Fuse Box

No 5 Fuse Box

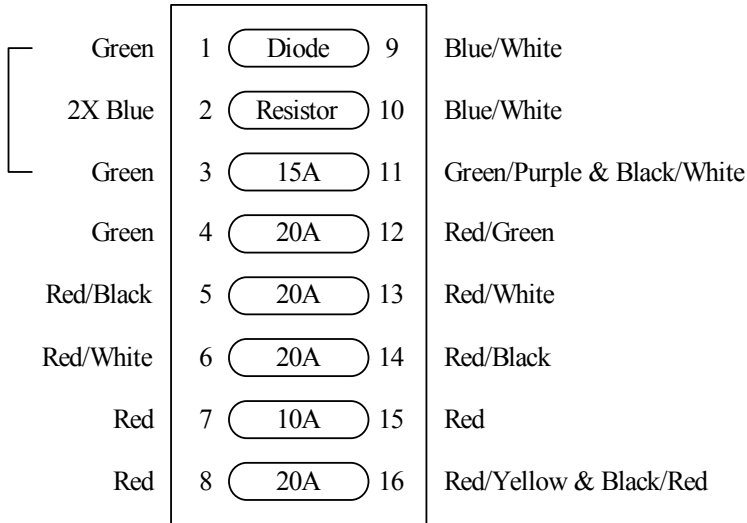
Correction 5/18/2005. Black/Red wire moved from No 6 Fuse Box Terminal 10 to No 5 Fuse Box Terminal 16. Terminal 7 changed from "To Fan Relay 86" to "To Auxiliary on Ignition Switch".
